**SUBJECT: FINAL REPORT—INDEPENDENT CONFIRMATORY SURVEY  
SUMMARY AND RESULTS FOR THE PLUM BROOK REACTOR  
FACILITY, SANDUSKY, OHIO (DOCKET NOS. 50-30 AND 50-185)  
DCN: 1760-SR-01-0**

**INDEPENDENT CONFIRMATORY  
SURVEY SUMMARY AND RESULTS  
FOR THE PLUM BROOK REACTOR  
FACILITY  
SANDUSKY, OHIO**

FIGURE 3: REACTOR OFFICE AND LABORATORY BUILDING - MEASUREMENT AND SAMPLING LOCATIONS

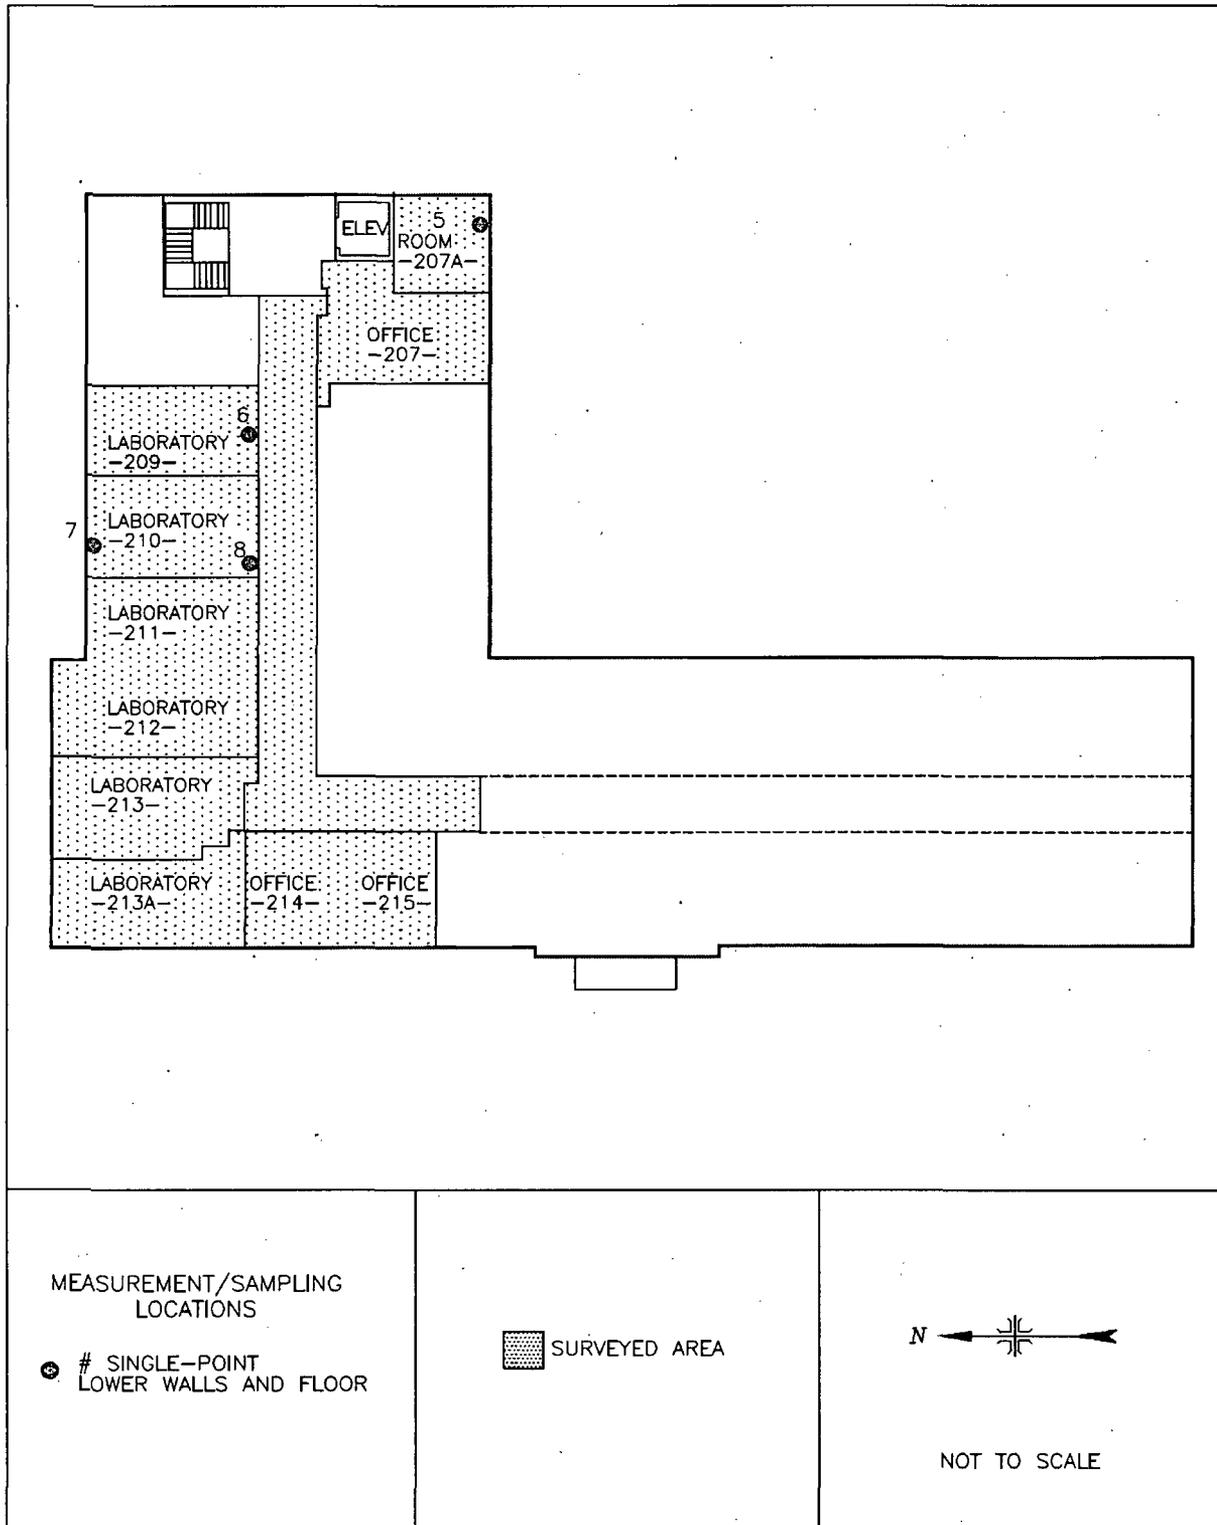
During onsite activities the licensee provided ORISE their survey design/survey request packages for each of the areas selected for confirmatory survey activities. The gross beta DCGL<sub>GB</sub> values varied across the site, therefore, the scan investigation levels for both the hand-held and the floor monitor detectors also varied from area to area. The survey request packages were very useful in providing specific instructions and guidelines to the technicians performing the FSS activities. However, while reviewing these packages, ORISE identified that the licensee's floor monitor scan investigation levels were set too high. The NRC and the licensee were notified of the issue. During the site closeout meeting, ORISE explained that the floor monitor issue results from the use of the total surface area of a large area distributed source for efficiency determination during calibration. Guidelines are based on 100 cm<sup>2</sup> and it is a fact that a small, high-activity point source could fall below the investigation level determined by the licensee (using the efficiencies determined from the large area distributed source) but be above the DCGL. The licensee stated that their documented scan procedure is to perform static measurements using the hand-held detectors at any locations identified by the floor monitor exhibiting an increase in activity. However, upon further review of NASA's procedures, it was determined by ORISE that the documented scan procedure did not reflect what was indicated to the NRC and ORISE as their procedure during the closeout meeting. NASA's *Procedure 4.3.2 - Scan Measurements for Beta/Gamma and Alpha Surface Activity*, is general in terms of specific detectors; therefore, in addition to hand-held detectors the applicability of this procedure to the floor monitor detector (Ludlum model 43-37) is also assumed (NASA 2007c). This being the case, the procedure says "IF the activity exceeds THE SURFACE SCAN INVESTIGATION LEVEL established by the SR (survey request), THEN perform the following: 1), 2), 3) OBTAIN STATIC MEASUREMENTS...." Further concern resulted from a location that ORISE specifically noted on the floor in the Chemical Lab of the ROLB (location 6) because it was

well below the licensee's floor monitor scan investigation level of 16,000 cpm with activity of approximately 5,000 cpm. However, the direct measurement at this location with a hand-held detector of 5,632 cpm resulted in 22,349 dpm/100 cm<sup>2</sup> (gross activity) which is just below the DCGL<sub>GB</sub> of 27,166 dpm/100 cm<sup>2</sup>. Extrapolation of this example indicates that values below the 16,000 cpm scan investigation level could result in activity greater than the DCGL<sub>GB</sub>. The findings were presented in an email to the NRC who indicated they would further discuss the issue with the licensee (ORISE 2008e).

Following issuance of the ORISE findings, the licensee suspended the use of the floor monitor detectors until the findings could be resolved and corrective actions implemented. The licensee first performed testing using a smaller 100 cm<sup>2</sup> source and confirmed that the PBRF scan action levels used to perform final status surveys in the ROLB and SEB were set too high to identify small high-activity point sources. The resolution implemented by the licensee was the calculation of revised (lower) floor monitor scan action levels that would account for smaller areas of activity (100 cm<sup>2</sup>) that would exceed the DCGL. The licensee confirmed the new action levels through a series of instrument source checks and efficiency determinations. In addition, the licensee opted to rescan all Class 2 and Class 3 floor surfaces within the ROLB and SEB using the new investigation levels. The licensee reported that the rescans did not identify activity greater than the new investigation levels. To prevent recurrence of this error, all FSS/Characterization Engineers were briefed and the licensee entered the issue into their corrective action database for tracking and recording (NASA 2008).

The licensee provided a thorough response regarding the immediate action and the steps taken in the resolution of the floor monitor scan action level finding (NASA 2008). The ultimate resolution

included the calculation of revised (lower) floor monitor scan action levels that would account for a smaller area of activity ( $100 \text{ cm}^2$ ) that would exceed the  $\text{DCGL}_{\text{GB}}$ , which is a conservative approach to ensure that the DCGLs would not be exceeded when the technicians refer to these values.
